# SERVICE BULLETIN No.1150

<b>COACH MODEL</b>	: C2045 w/ D-ELSA brakes
<b>BULLETIN TYPE</b>	: Product Improvement
<b>MANUAL SECTION</b>	: Section 8 - Suspension
<b>DATE</b>	: July 19, 2006
<b>SUBJECT</b>	: <b>Kneeling sensor installation</b>
<b>TERMS &amp; CONDITIONS</b>	: Refer to the Parts and Products section in this Bulletin.

**Figure 1.2: New installation**

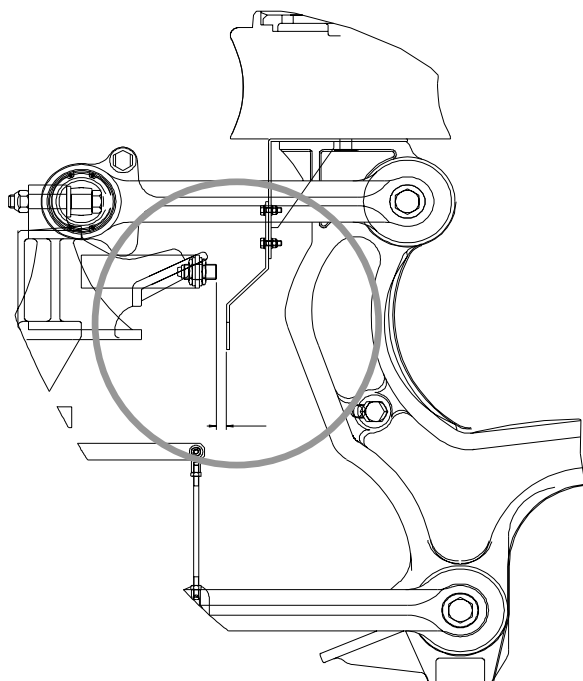
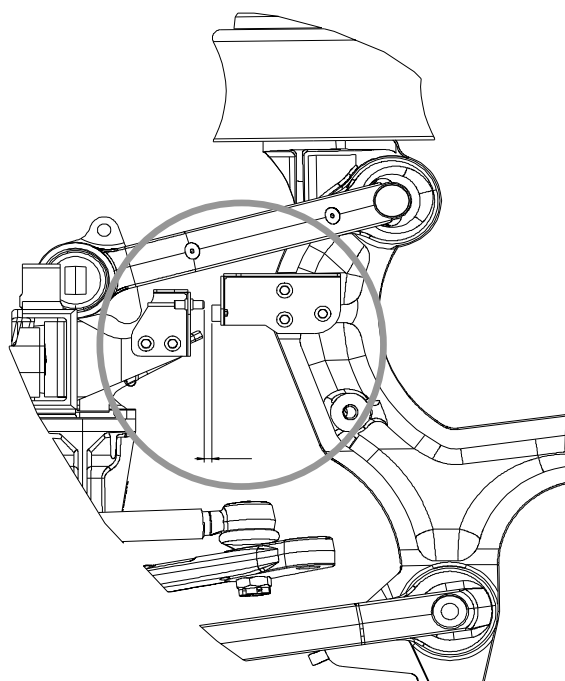
1. In the previous installations, the kneeling sensor assembly, which is located on the front axle near the upper right hand wishbone, comprises an inductive or magnetic sensor, a mounting bracket for the sensor, and a bracket, which bolts to the air spring base plate (Figure 1.1). During the final stage of the kneeling process this bracket triggers the sensor and cuts the kneeling action, in order to maintain a residual pressure in the front axle air springs.

2. For protection purposes and to ensure reliable kneeling sensor operation, the afore-mentioned installations of the sensor and associated trigger have been revised. A new sensor bracket has been designed relocating the assembly to a position 2 inches (50 mm) higher in the chassis. The new trigger bracket bolts to the suspension upright (Figure 1.2).

- **VH 10948706**
  - magnetic sensor
  - revised brackets relocating the assembly two inches (50 mm) higher
  - trigger bracket with magnet bolted to upright

**Figure 1.1: Retrofit installation for magnetic sensor**

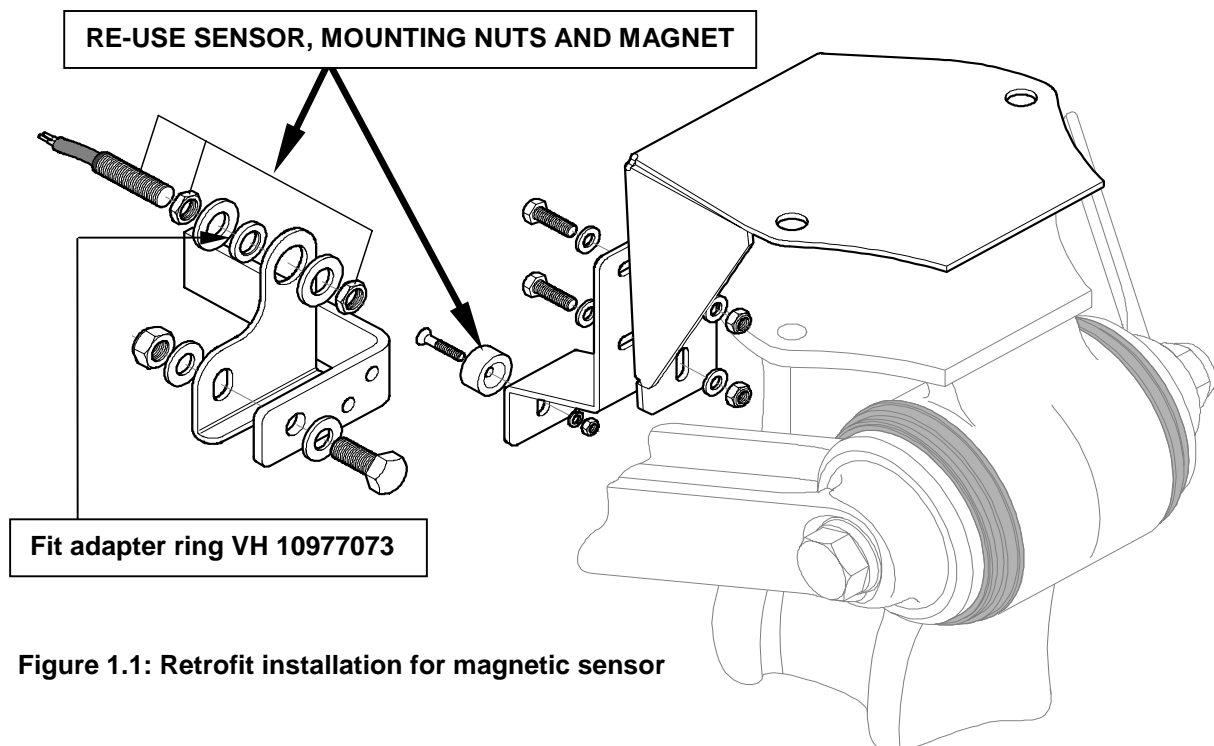
- 4) Magnetic sensor only: undo and remove the flat head screw and nut securing the magnet to the old trigger bracket.  
Recover the magnet.
- 5) Inductive sensor only: install adapter ring VH 10977073 in the sensor mounting hole of the L-shaped bracket.

- 7) Magnetic sensor only: install adapter ring VH 10977073 in the sensor mounting hole of retrofit bracket VH 10977074.
- 8) Install the sensor loosely in the top hole of the retrofit bracket. Magnetic sensors will require two M10 flat washers for a proper fit.

- 9) Magnetic sensors only, attach the magnet to the bottom lip of retrofit trigger bracket VH 10952940, using M4 mounting hardware.  
Tightening torque 25 in.lbf.

Air gap:           inductive sensor : 5/32 inch (4 mm).  
                      magnetic sensor: 5/16 to 25/64 inch (8 to 10 mm)

**Figure 1.2: Retrofit installation for inductive sensor (no magnet)**

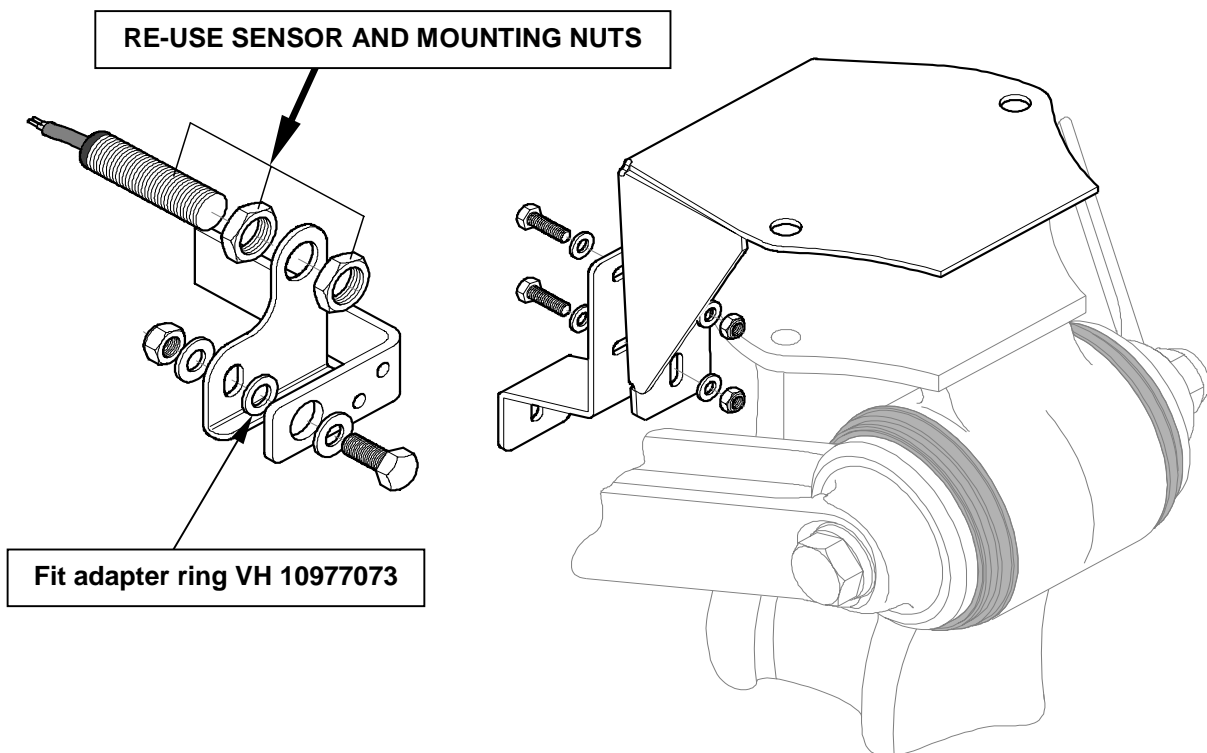
- 6) Assemble retrofit sensor mounting bracket VH 10977074, M10 bolt, nut and washers as shown in Figure 2.  
Secure to the L-shaped bracket.  
Tightening torque 30 ft.lbf (40 Nm).
